Model number: SML385BTBK
Version: US
Date: 24th FEB, 2016

★ Changes in Red

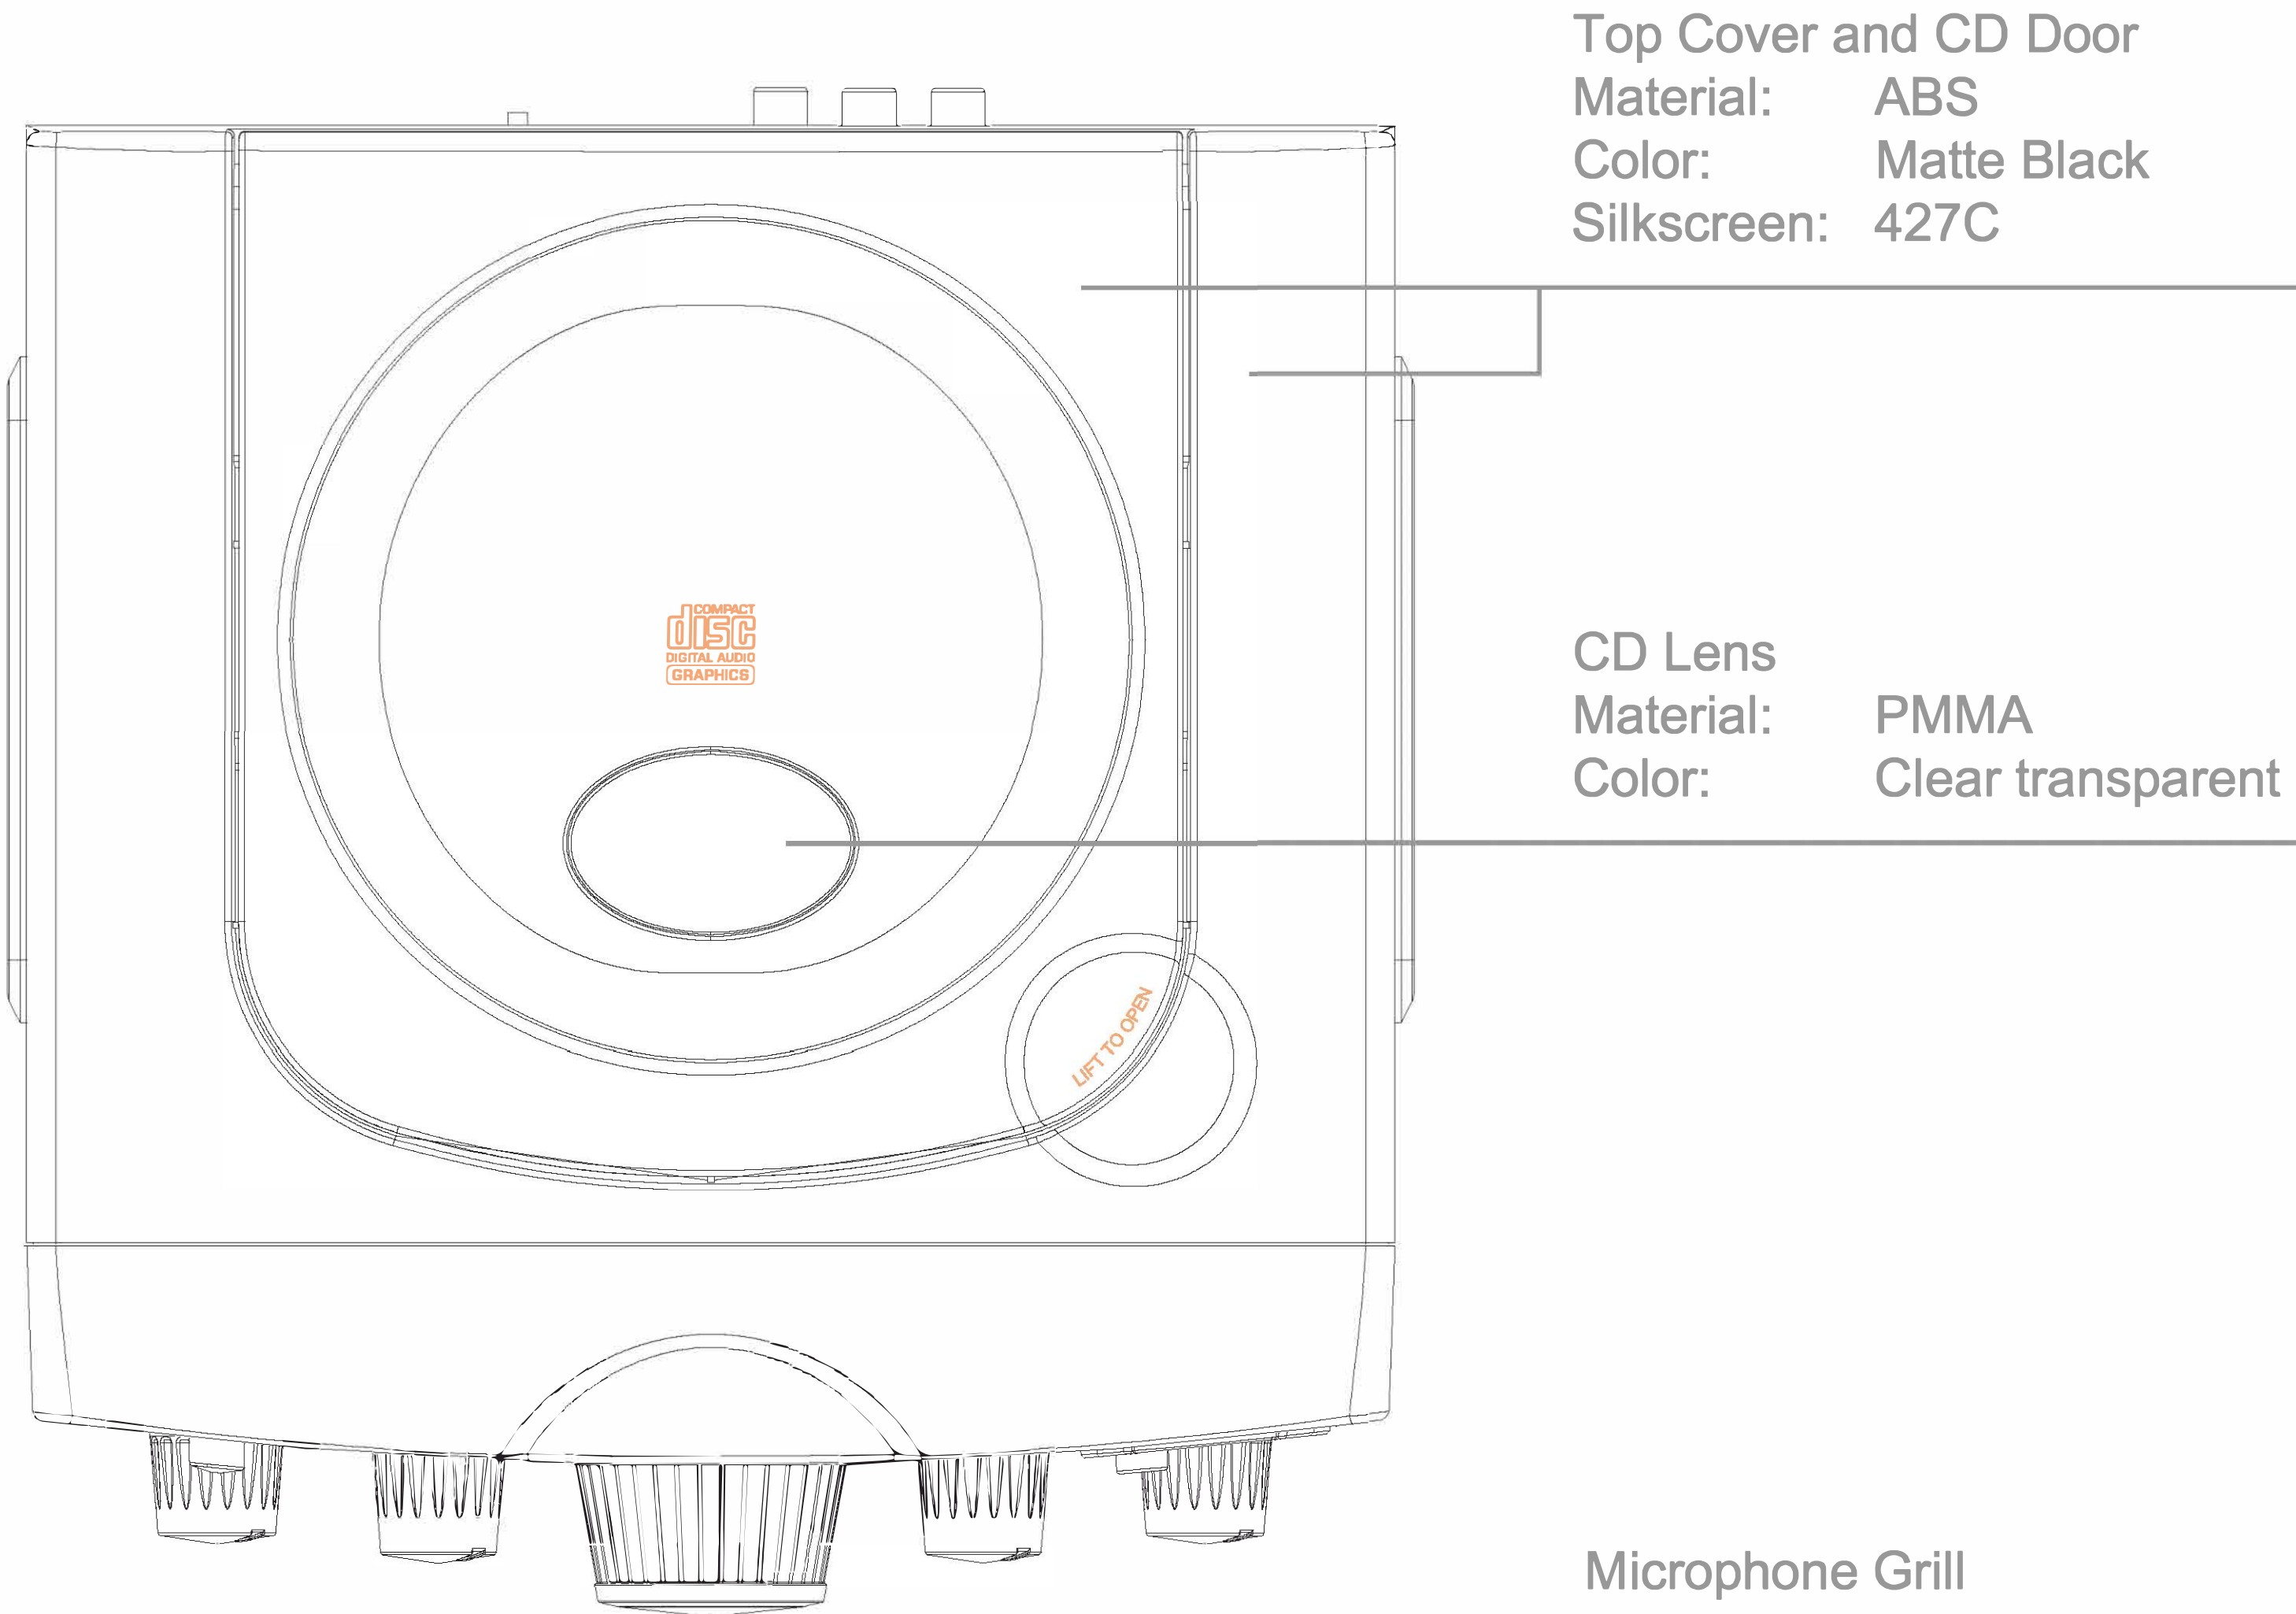
★ BT logo
Silkscreen: 427C

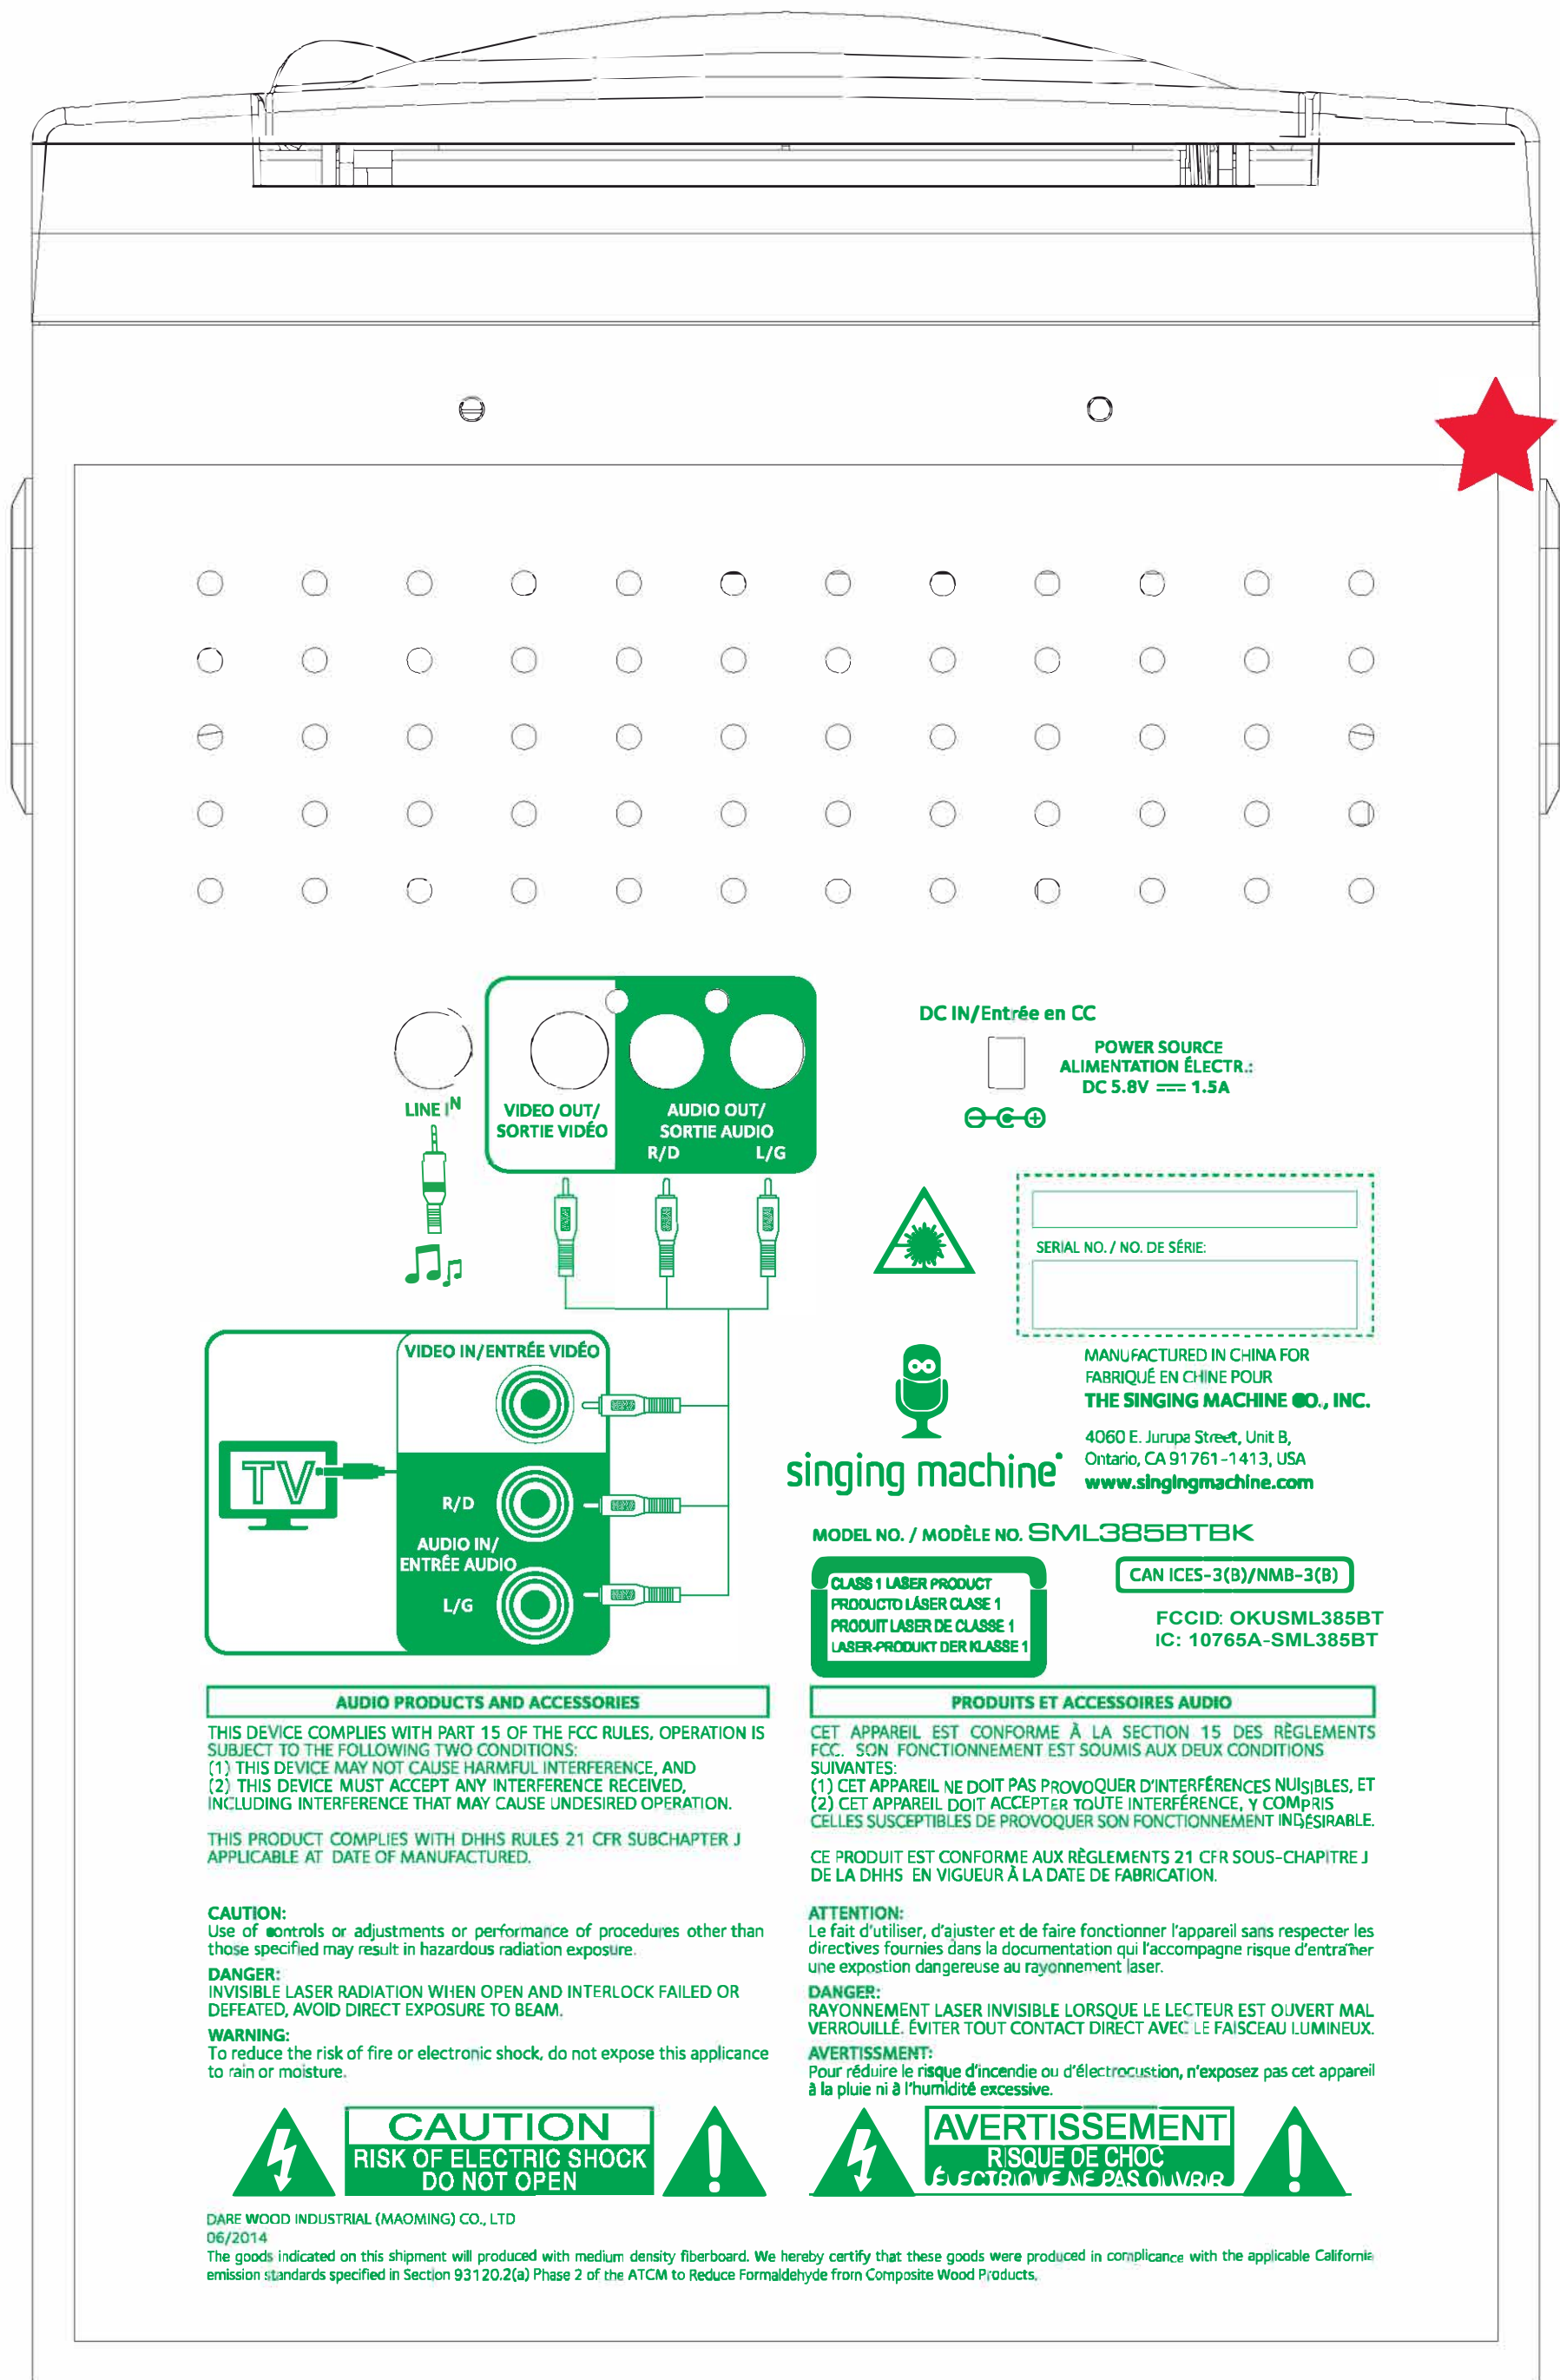
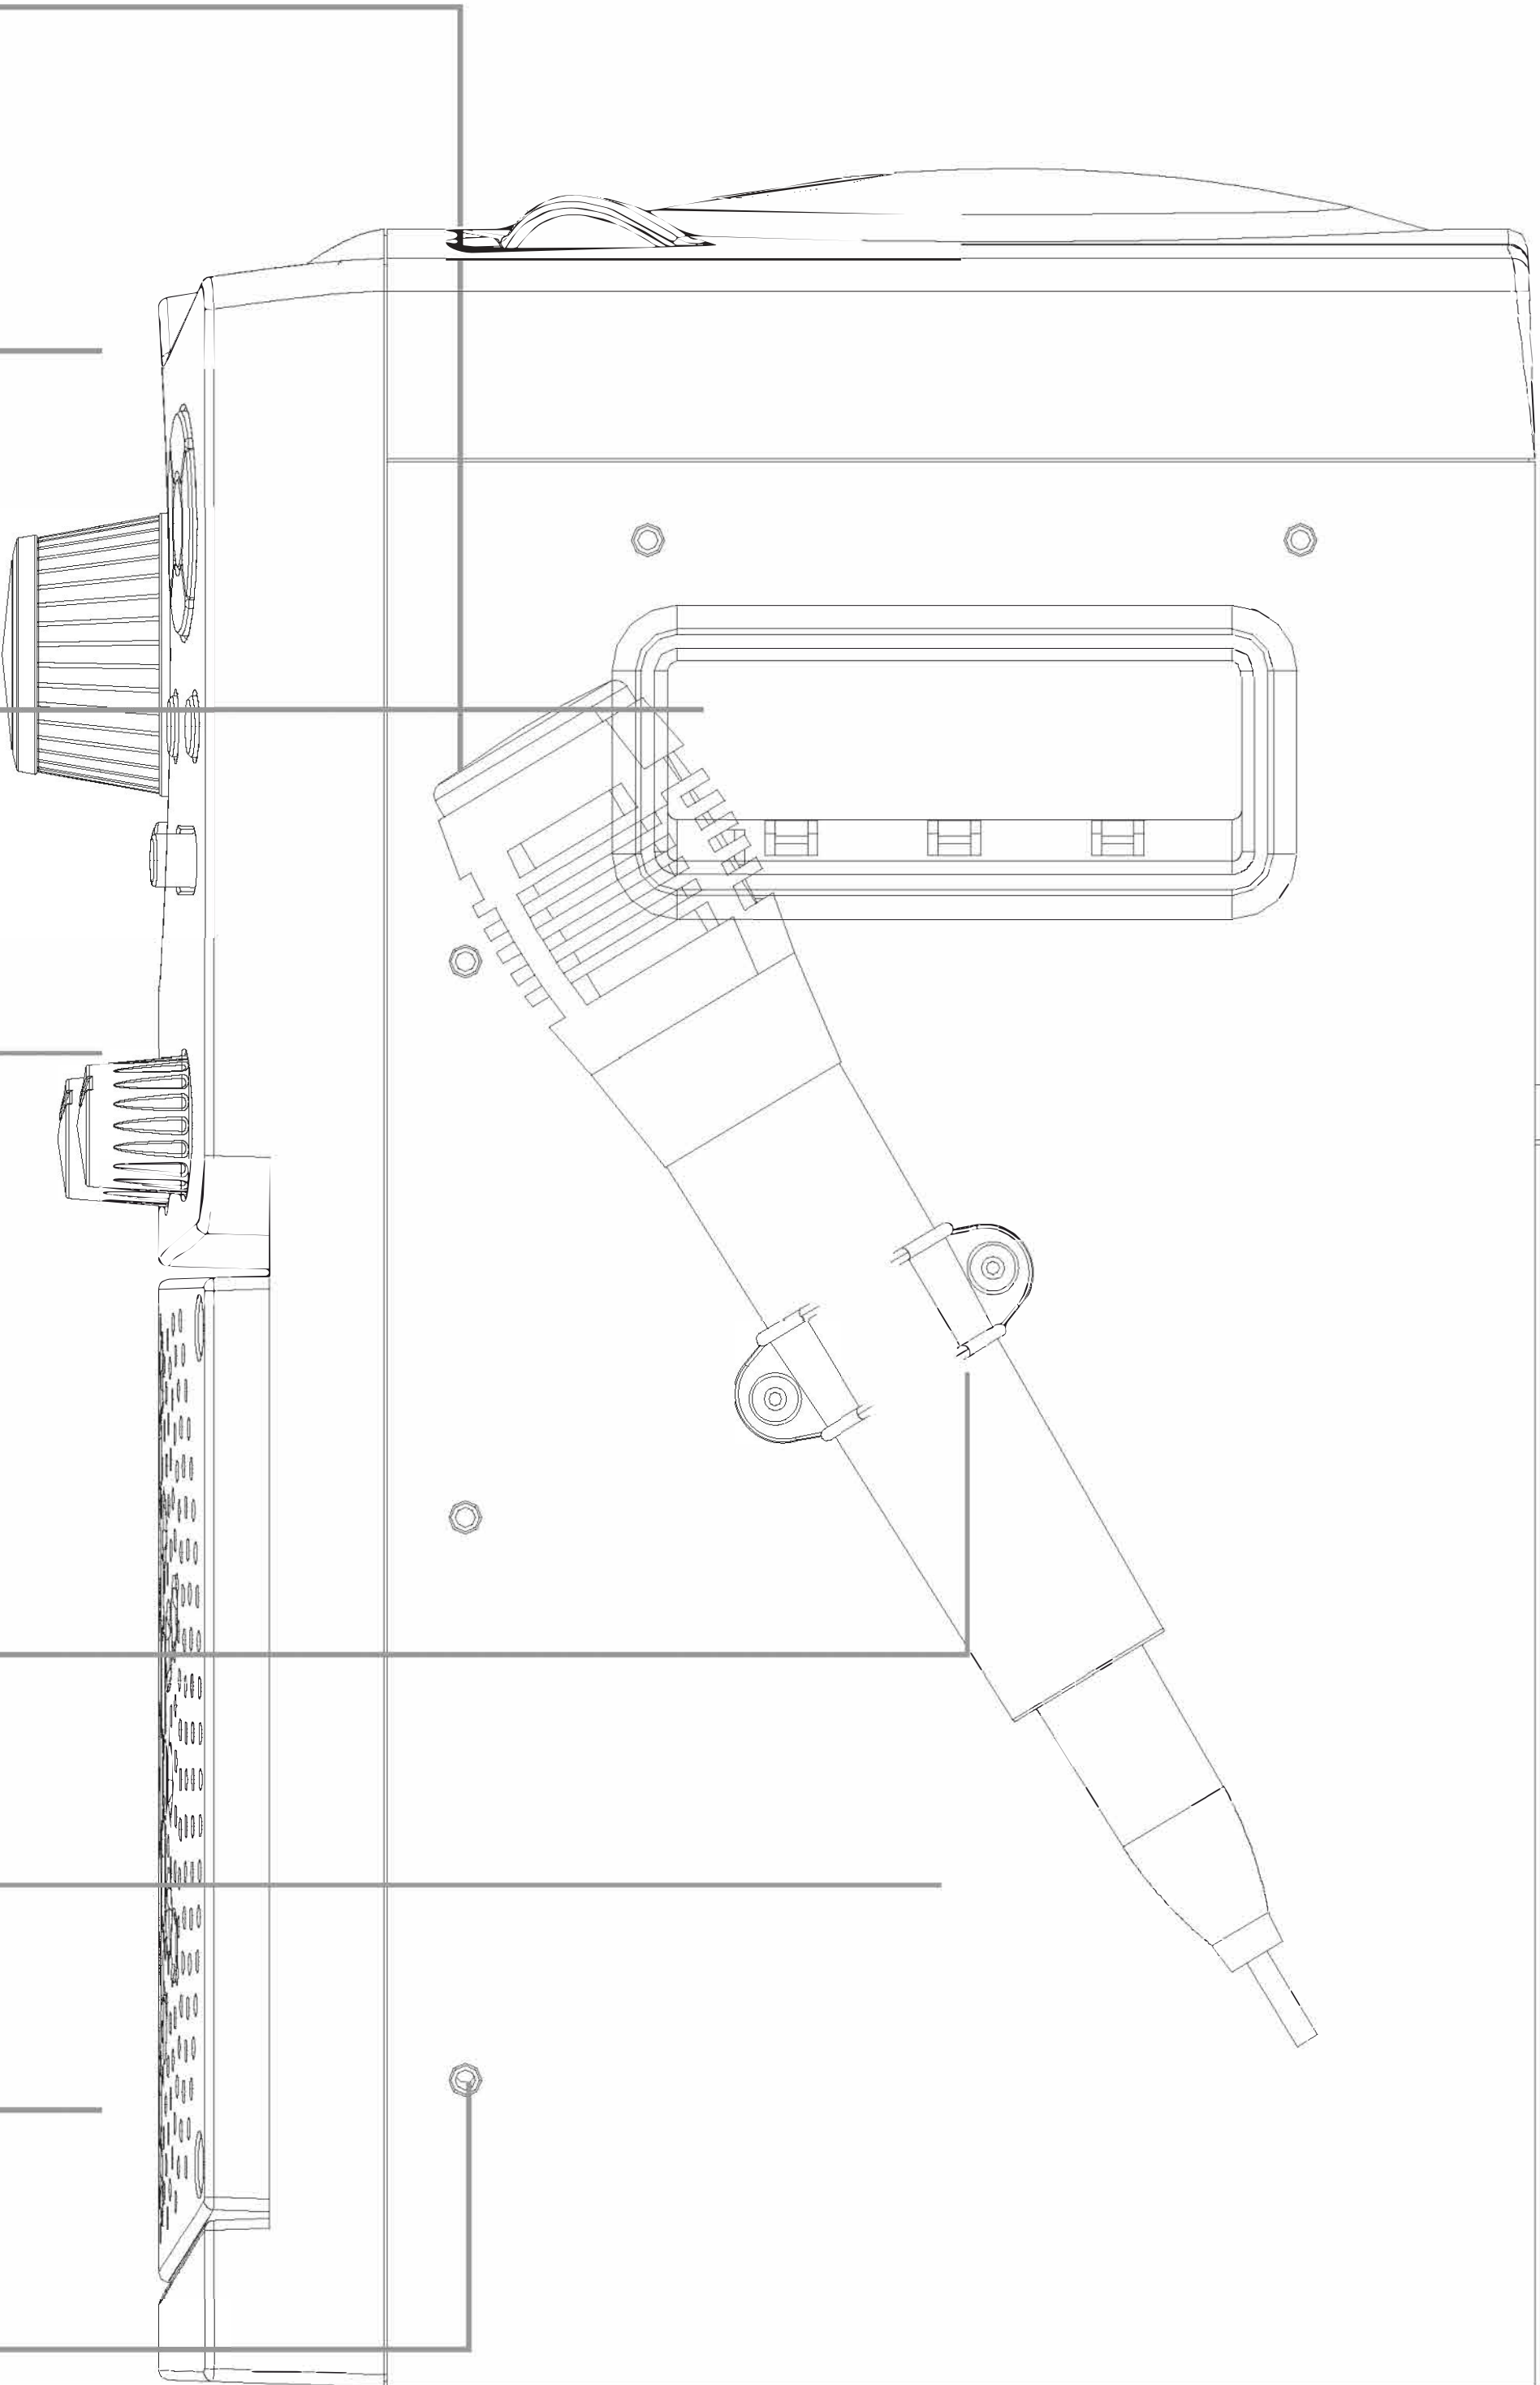
★ Rear board silkscreen updated because QC comments the lowest part is too close too the edge of the board.
